Access Compliance Report

Public Rights-of-Way

(Curb Ramps)

Intersection ID: 45494	Main Street: BUGGY_HORSE_RD	Cross Street: COTTON_STAND_RD	Location: S
ADA ID: 115B30F23FB3	Ramp Type: Perp	Initial Pass/Fail: Pass	Overall Compliance: No
Severity Score: 5.25			
Codes/Mitigation Info/Possible Solution		Field Measurements/Component Compliance

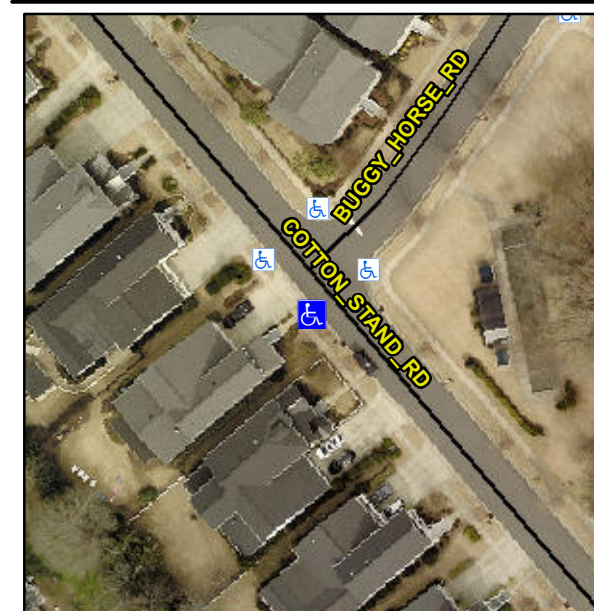
Not Found, R304.2.2-Perp, R304.3.2-Para, R304.5.4, R304.5.3

**Remove & Replace Entire Ramp.
Remove & Replace Gutter.**
